## Elkhart County Parks Administration

211 West Lincoln Avenue

Location		Structural Inconsistencies		Recommended Corrections/Modifications to Provide Access	Technical Information			Finalized Actions		
Location	Photo	Identified Issue	ADAAG Specification		Priority Ranking and Justification	Improvement Cost	Funding Source	Finalized Correction	Anticipated Date of Completion	Date of Completion

01. Parks Dept Parking Lot

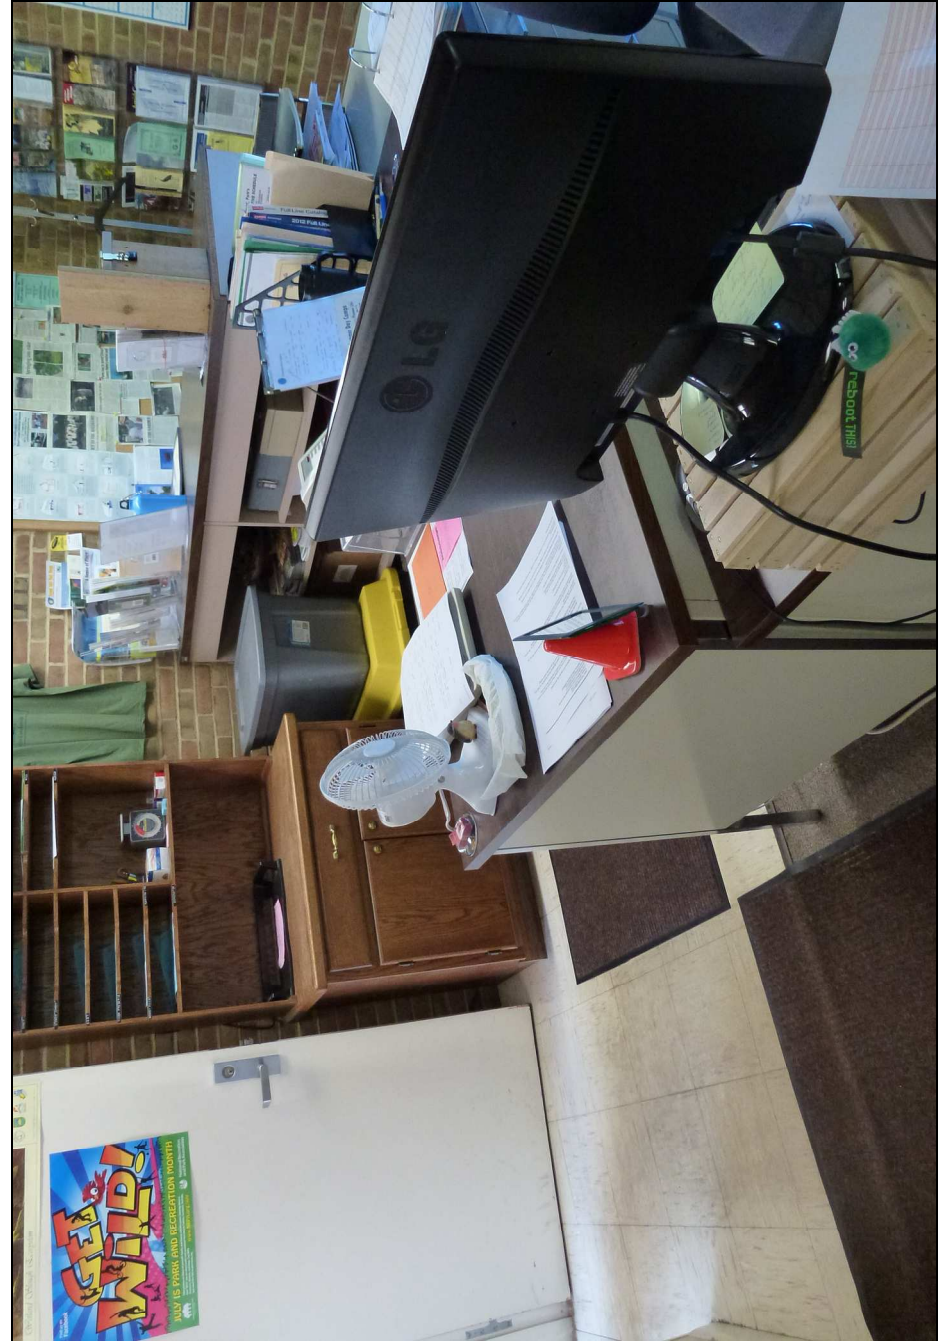
1. Parking	1	No "Van Accessible" sign at van accessible parking space. No enforcement procedure for accessible parking	4.6.4	ADAAG requires accessible parking spaces to be located in each parking lot. Accessible parking spaces are required to have upright signage that includes the symbol of a accessibility and van accessible signage where required. <b>Add one "Van Accessible" sign. Enforce parking regulations.</b>	<b>L</b> : Space is adequate for vans, just no sign posted.	\$50	Elkhart County General Fund	<b>Van accessible sign installed.</b>		<b>Jul-14</b>

02. Parks Dept Service Counter

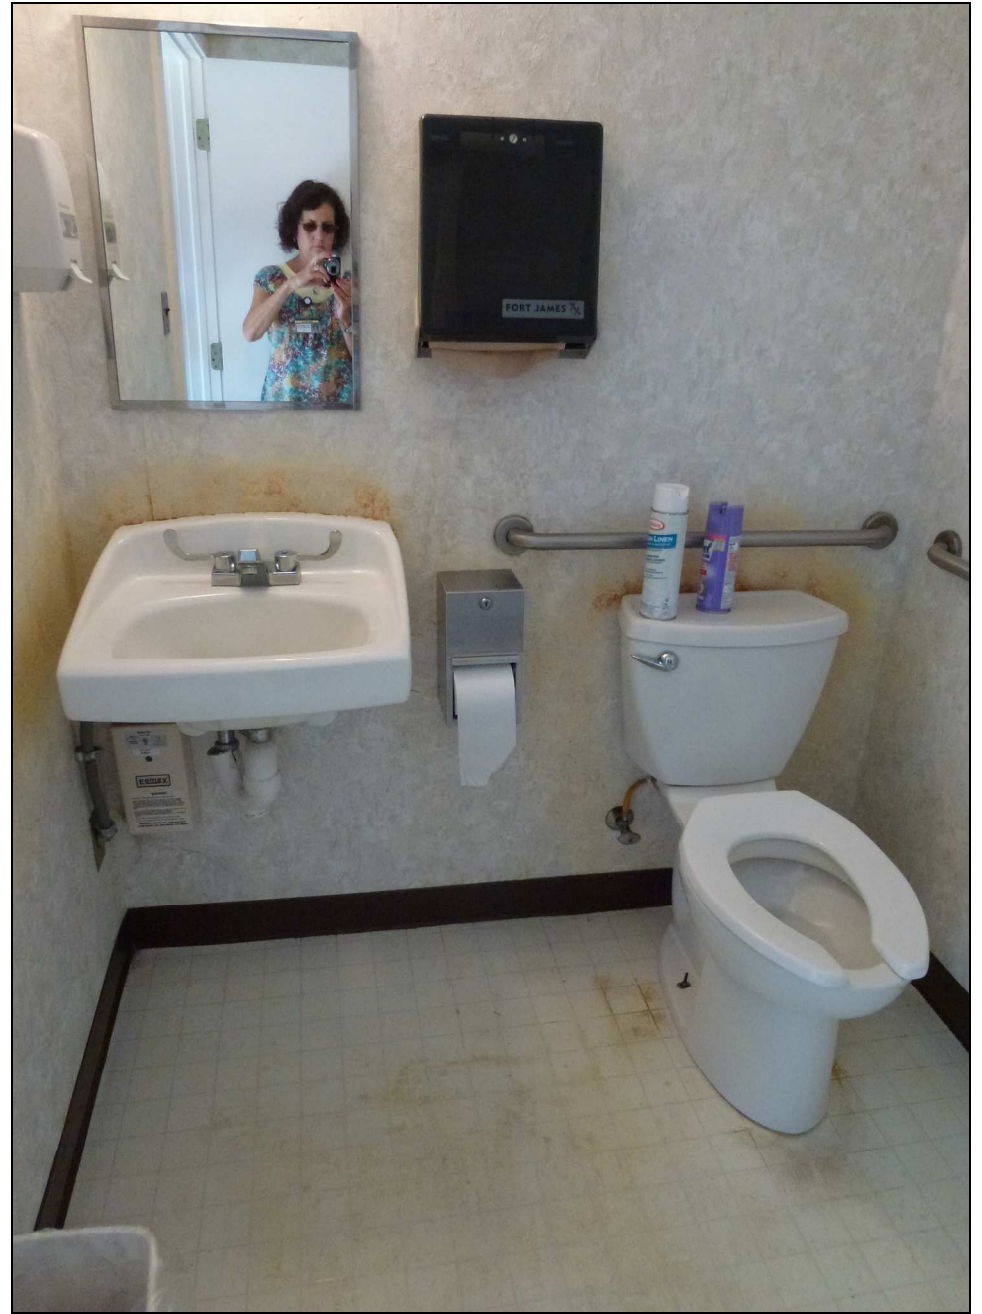
2. Main work area	2	Aisles and pathways to materials and services do not meet the minimum required width. Aisles are 35 in wide.	4.2.1	ADAAG requires the minimum clear width for single wheel chair passage to be 32 in at a point and 36 in continuously. <b>Move desks and furniture to configure a wider space for accessibility.</b>	<b>H</b> : This can be completed with minimal effort and cost.	\$100	Elkhart County General Fund	<b>Reconfigured furniture</b>		<b>Jul-05</b>
